Contact: Scott Shearer
© 01835 826732 Ref: 13/00401/FUL

Nature of Proposal: Erection of 12 holiday cabins, office/laundry block and associated works

Site: Land South West Of Milldown Farmhouse Coldingham Scottish Borders

The above is stated within the 14-C-191-SK 01 Rev D drawing and already had this topographical information that was provided within the attachment on your e-mail dated 19th January 2015, so this data had previously been seen.

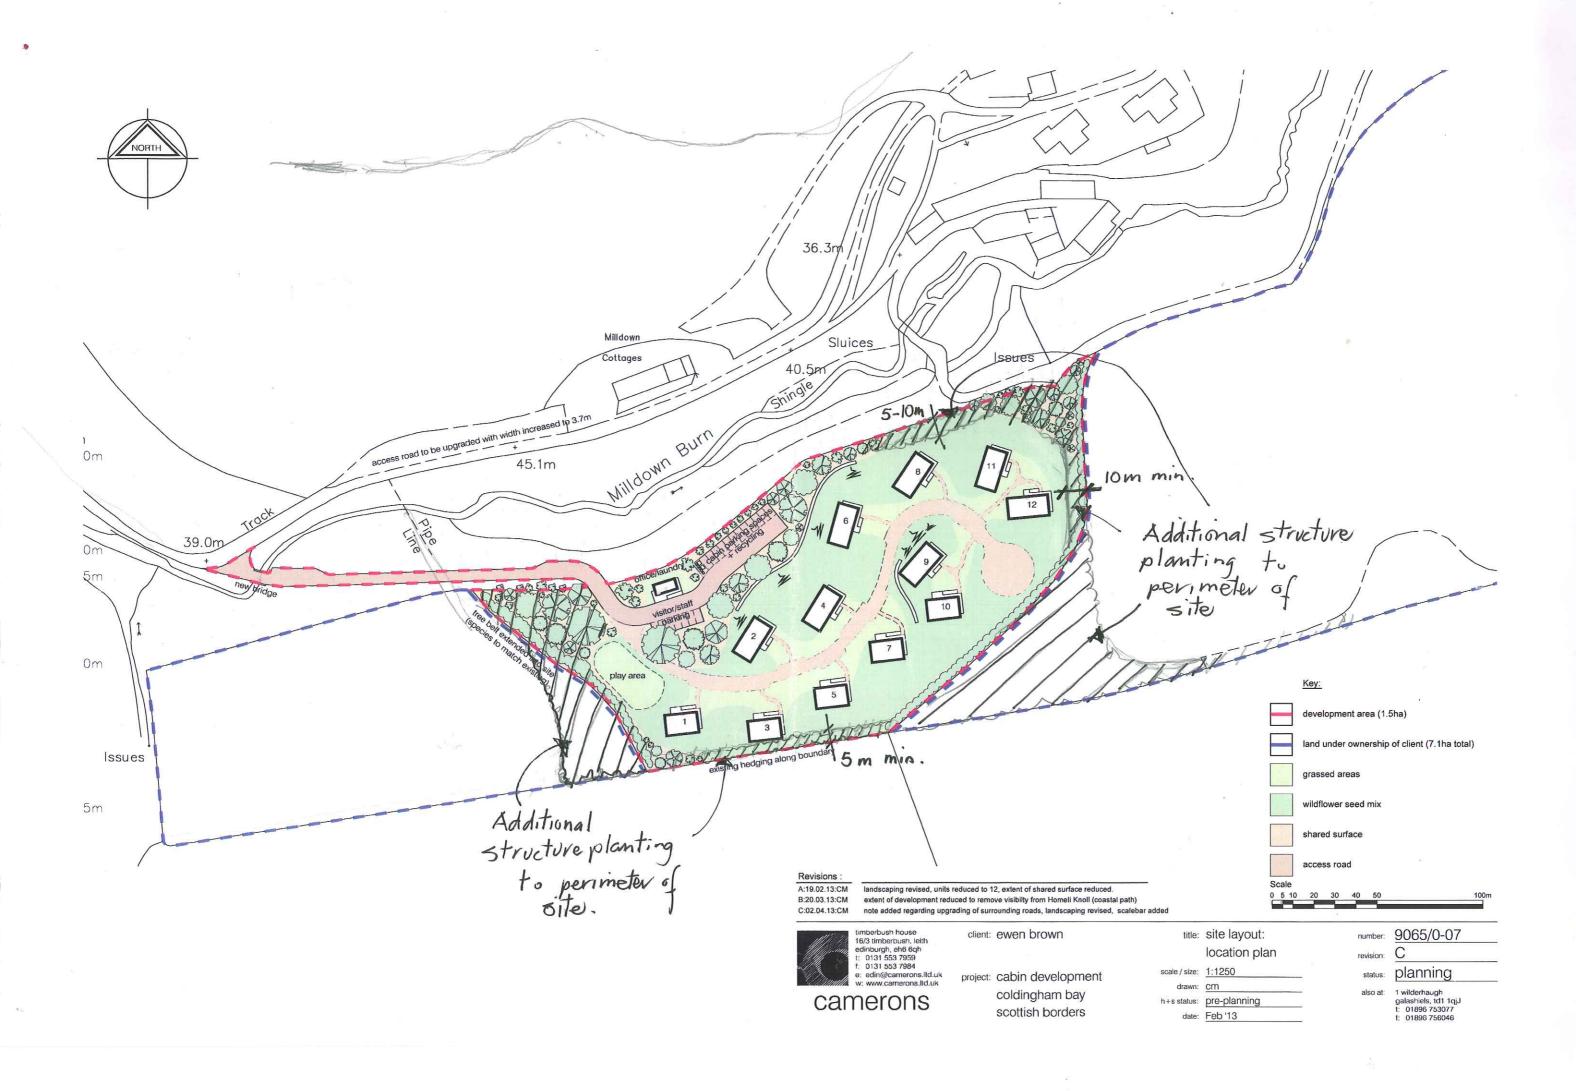
"The notes on the drawing state that size of the arch box culvert has been designed to accommodate the 1 in 200 year flows, in my previous response I stated that I would require a Flood Risk Assessment to be undertaken to develop a 1 in 200 year plus a 20% allowance for climate change flood level to inform the bridge design. This is still required. I would also request that SEPA's hydrologists are consulted to assess the methodologies and data used to develop the flood level."

Therefore, there will be no change in the response and the FRA to develop a 1 in 200 year plus climate change flood level will still be required to inform the bridge design.

It is still the case that we do not think that there is a need for a debris grille.

It is still the case that a cut-off drain should be built to mitigate the risk of surface water runoff.

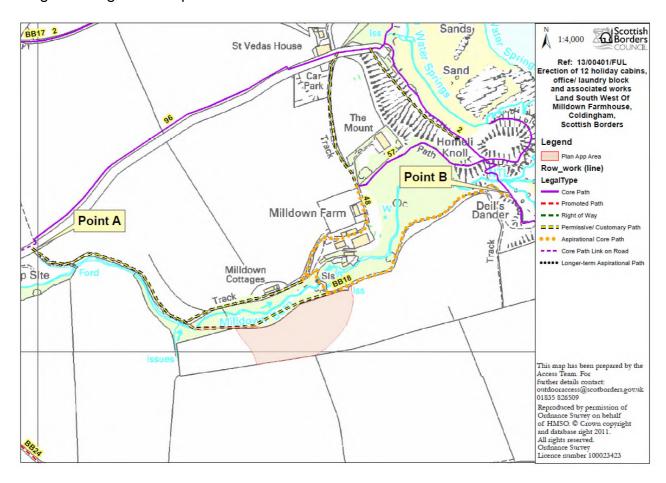
Further to my review of the application, there are pathways (as outlined on the attached Plan) which are accessible to the public under the Land Reform (Scotland) Act 2003 that will be affected by this application.

The route which gives access from the unclassified road to Coldingham Bay, gives access to the small bay south of Coldingham Bay and onto both the Berwickshire Coastal Path and Coldingham Bay. It is undoubtedly used regularly by both the local community and visitors to the area.

The access roadway from the unclassified road should incorporate adequate width to accommodate pedestrians, cycles and horses along the entire length of the route, providing suitable surface to the access roadway and a suitable bridge crossing.

From the access roadway it would be beneficial to the development that 'Coldingham Bay & Berwickshire Coastal Path' be signposted and accordingly suitably surfaced to 'Deil's Dander'.

- The path indicated (Points A − B) must be maintained open and free from obstruction in the course of development and in perpetuity and shall not form part of the curtilage of the development area and / or properties. Reason: To protect general rights of responsible access.

- place until a scheme for the temporary diversion and restoration of path number (Points A - B) has been submitted to and approved by the Local Planning Authority and the development shall be implemented in accordance with the said scheme. Reason: To protect general rights of responsible access.

- Should any new bridge crossing of the Milldown Burn be installed, the structure should accommodate all anticipated path users together with vehicles. No development shall take place until a scheme outlining the bridge crossing to facilitate public access along the path (Points A - B) has been submitted to and approved by the Local Planning Authority and the development shall be implemented in accordance with the said scheme. Reason: To protect general rights of responsible access.

- The path indicated (*Points A* B) must be surfaced accordingly (e.g. locally sourced aggregate: type 1 to dust) in order to accommodate anticipated increased demand on the route to the satisfaction of and approved by the Local Planning Authority and the development shall be implemented in accordance with the said scheme. Reason: To protect general rights of responsible access.

- The path indicated (*Points A B*) must be signposted accordingly (e.g. timber fingerposts) in order to facilitate anticipated increased demand on the route to the satisfaction of and approved by the Local Planning Authority and the development shall be implemented in accordance with the said scheme. Reason: To protect general rights of responsible access.

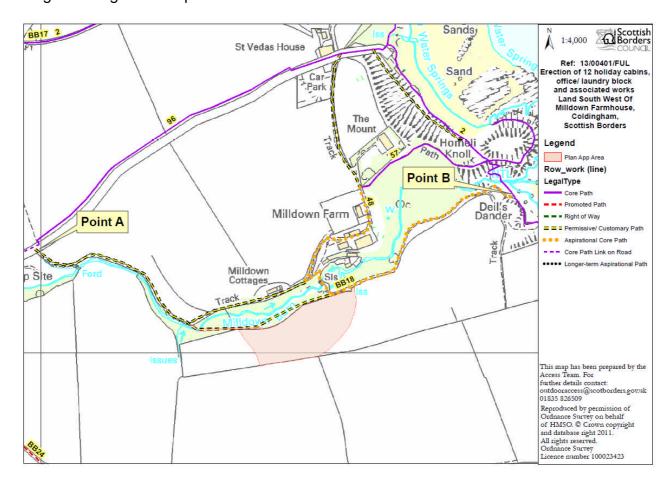
Further to my review of the application, there are pathways (as outlined on the attached Plan) which are accessible to the public under the Land Reform (Scotland) Act 2003 that will be affected by this application.

The route which gives access from the unclassified road to Coldingham Bay, gives access to the small bay south of Coldingham Bay and onto both the Berwickshire Coastal Path and Coldingham Bay. It is undoubtedly used regularly by both the local community and visitors to the area.

The access roadway from the unclassified road should incorporate adequate width to accommodate pedestrians, cycles and horses along the entire length of the route, providing suitable surface to the access roadway and a suitable bridge crossing.

From the access roadway it would be beneficial to the development that 'Coldingham Bay & Berwickshire Coastal Path' be signposted and accordingly suitably surfaced to 'Deil's Dander'.

- The path indicated (Points A − B) must be maintained open and free from obstruction in the course of development and in perpetuity and shall not form part of the curtilage of the development area and / or properties. Reason: To protect general rights of responsible access.

- place until a scheme for the temporary diversion and restoration of path number ($Points\ A-B$) has been submitted to and approved by the Local Planning Authority and the development shall be implemented in accordance with the said scheme. Reason: To protect general rights of responsible access.

- Should any new bridge crossing of the Milldown Burn be installed, the structure should accommodate all anticipated path users together with vehicles. No development shall take place until a scheme outlining the bridge crossing to facilitate public access along the path (*Points A − B*) has been submitted to and approved by the Local Planning Authority and the development shall be implemented in accordance with the said scheme. Reason: To protect general rights of responsible access.

- The path indicated (Points A − B) must be surfaced accordingly (e.g. locally sourced aggregate: type 1 to dust) in order to accommodate anticipated increased demand on the route to the satisfaction of and approved by the Local Planning Authority and the development shall be implemented in accordance with the said scheme. Reason: To protect general rights of responsible access.

- The path indicated (Points A − B) must be signposted accordingly (e.g. timber fingerposts) in order to facilitate anticipated increased demand on the route to the satisfaction of and approved by the Local Planning Authority and the development shall be implemented in accordance with the said scheme. Reason: To protect general rights of responsible access.
